Supporting material for comment i-71

Adee Ran, Cisco

Figure 120G–10—Example module stressed input test

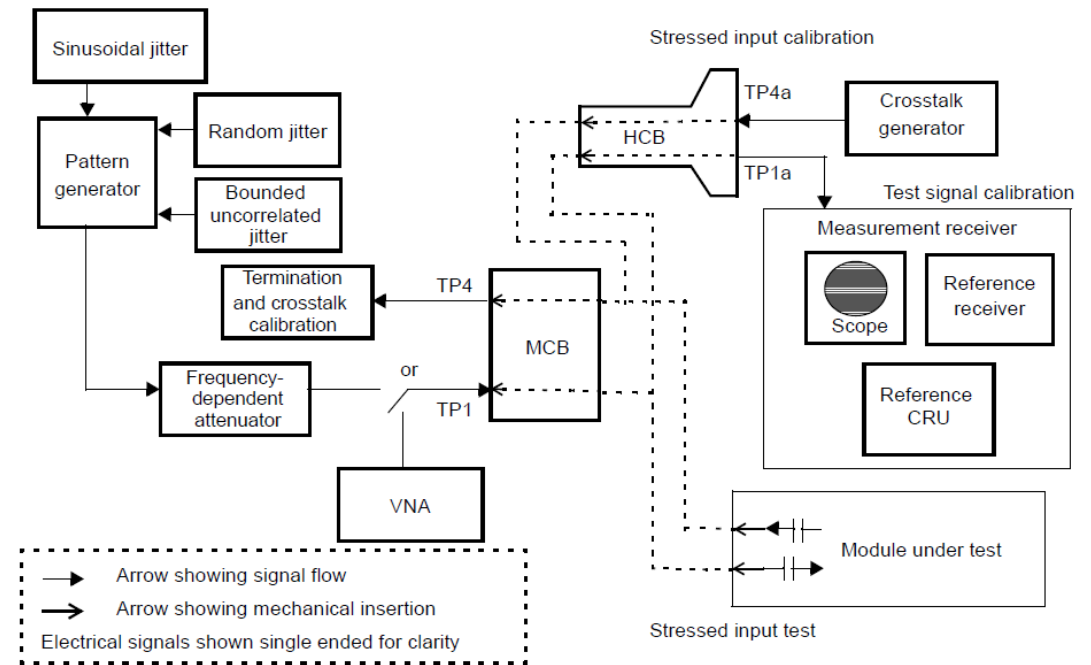
This should be TP1a – TP4 is copy-paste inherited from the host stress input test.

- g) Eye height and VEC are measured at TP1a as described in 120G.5.2 ~~with the exception for the high-loss case that the reference receiver CTLE setting that minimizes VEC has $g_{DC} + g_{DC2}$ less than or equal to -10.5 dB.~~ For the high-loss case, an exception is made that the reference receiver CTLE is limited to settings where $g_{DC} + g_{DC2}$ is less than or equal to -10.5 dB.

- h) The pattern generator amplitude, output equalization, and random jitter are adjusted together, ~~while the pattern generator output equalization and reference receiver settings are adjusted~~ to minimize VEC, so that the eye height of the smallest eye matches the target value, ~~and~~ VEC is within the limits in Table 120G–10, and the differential peak-to-peak voltage measured at TP4TP1a does not exceed the differential peak-to-peak input voltage tolerance given in Table 120G–9. The pattern generator output equalization has to be set such that for the resulting signal, the lowest VEC is achieved with a reference receiver CTLE setting within the limited range.

IL of the channel

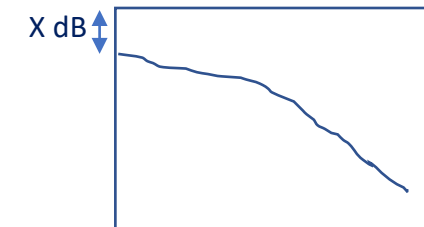
Spectrum of the signal with partial Tx equalization (input to the DUT)

Spectrum of the signal with Tx equalization + chosen setting of the reference CTLE (not fully equalized – some ISI remains for the DFE)

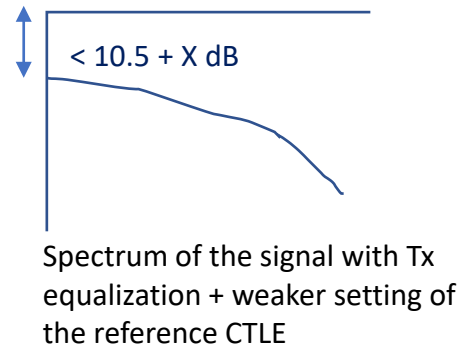
- The concern raised was: What if a “weaker” CTLE setting (lower $g_{DC}+g_{DC2}$) creates a lower VEC? Does it make life easier for the DUT?
 - But the PG output equalization is fixed!
 - If the DUT tries a weaker CTLE the DC attenuation will be lower \Rightarrow less optimized overall equalization
 - The DFE may compensate somewhat but it is too short to correct the discrepancy
- It might be possible to create a better signal for the DUT if the PG output equalization were adjusted to compensate for the weaker CTLE
 - But the DUT can't do that – **the stress signal is not adjusted at this point!**
